TECHNICAL MODIFICATIONS FOR THE FLOWER MARKET PROJECT; CF 19-1048 / 19-1048-S1

CF 19-1048, CASE NO. VTT-74568-1A

Revised Exhibit A

**5TH FLOOR
RESIDENTIAL/COMMERCIAL**
UPPER ELEVATION: 71.5'
LOWER ELEVATION: 59.5'

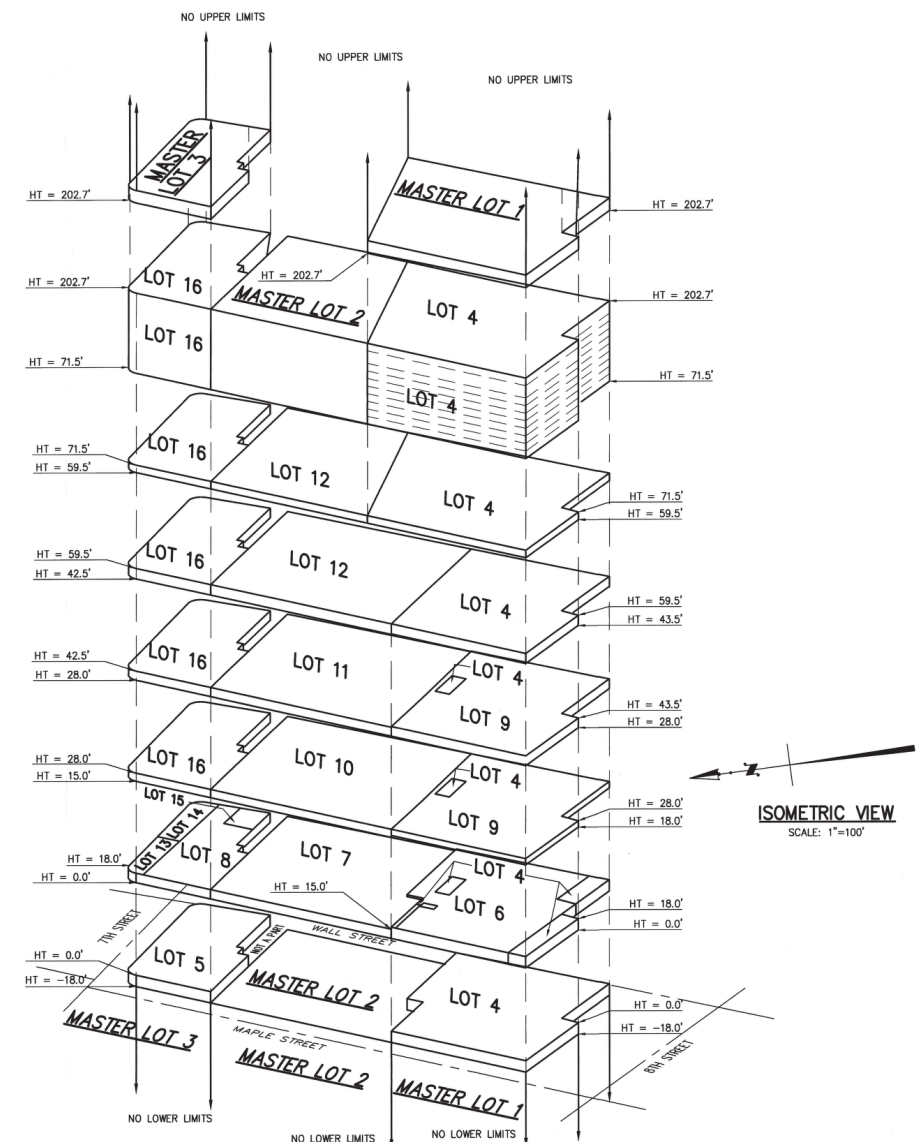
The Letter of Determination (LOD) for VTT-74568, dated June 3, 2019, referenced a Vesting Tentative Tract (VTT) map stamped-approved July 11, 2018. However, a map stamp-dated October 15, 2016 was inadvertently attached to the LOD as the approved Exhibit A, and carried forward as part of the Exhibit C in the Appeal Report to the CPC dated August 8, 2019. The correct map is actually dated February 9, 2018, and was inadvertently referenced with the July date due to a separate stamp on the map from the Department of Building & Safety Grading Division dated July 11, 2018.

Staff recommends that that any reference in the Vesting Tract Map LOD and Conditions of Approval to the July 11, 2018 date be replaced with the February 9, 2018 date; and that the VTT map dated February 9 2018, attached an Enclosure to this letter, replace the existing Exhibit A wherever referenced.
